# Development Management Sub Committee

**Application for Planning Permission 21/00991/FUL  
At 27 Arthur Street, Edinburgh, EH6 5DA  
Demolition of existing buildings and structures; erection of  
33 apartments and associated development (as amended).**

## **Application for Planning Permission 21/00991/FUL At 27 Arthur Street, Edinburgh, EH6 5DA Demolition of existing buildings and structures; erection of 33 apartments and associated development (as amended).**

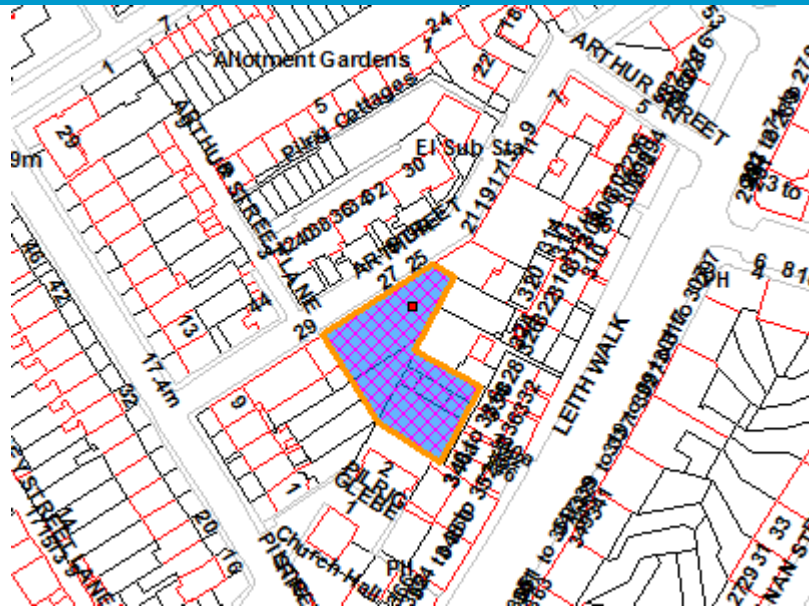
*The external store is considered to be acceptable in terms of security and weatherproofing and is understood to have easy and level access to the proposed lane.*

*IV. The preference for new build developments is always for cycle storage to be internal within the building at ground floor with easy and level access. The internal store is to be shared between Blocks A and B and whilst this is not ideal, particularly in terms of convenience of access for Block A, however considering the complexities of the site the cycle parking proposals are considered acceptable. The following guidance was considered*
